Certificate of Appropriateness

3014 W. McKinley Boulevard, Cold Spring Historic District

Remove brick from west side of the property bay window area. Install Tyvek barrier and reinstall brick to match historic appearance.

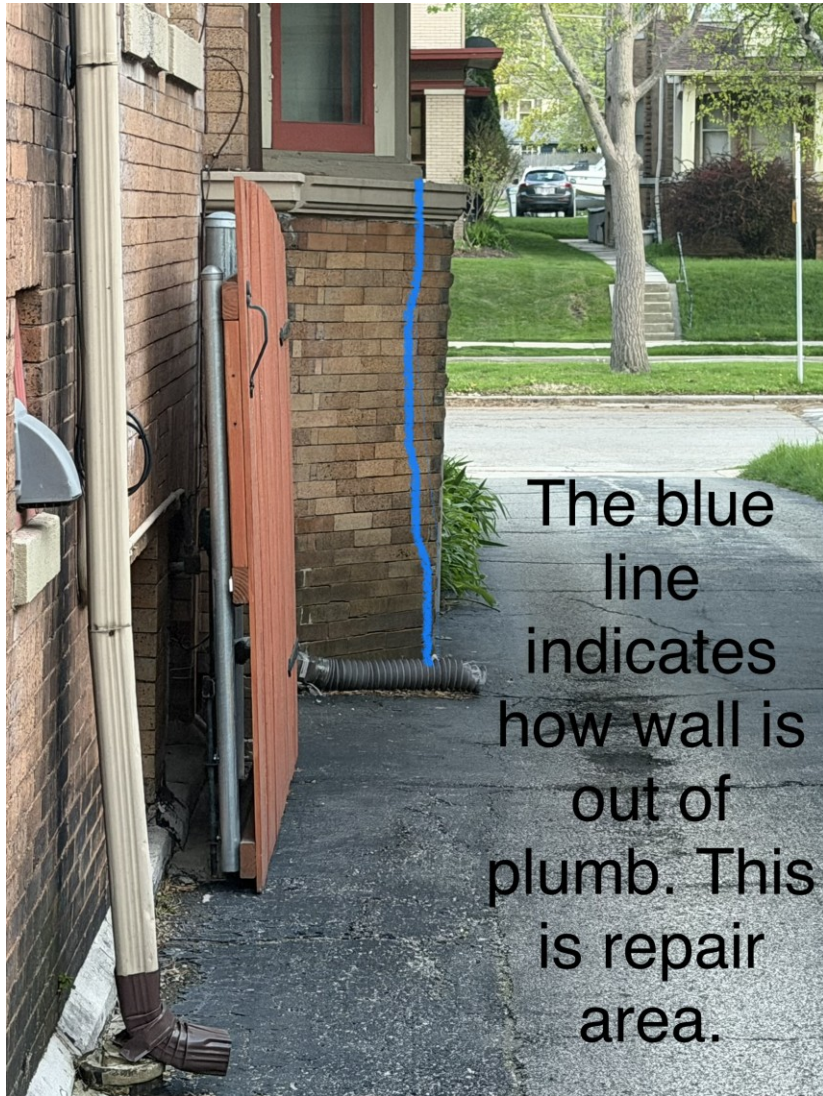
The blue line indicates how wall is out of plumb. This is repair area.

Wall under bay window to be rebuilt

Wall to be rebuilt. Corner details will be replicated exactly as they presently appear.

- 2) **Decorative corner detailing to be rebuilt and replicated exactly as it historically appeared.**
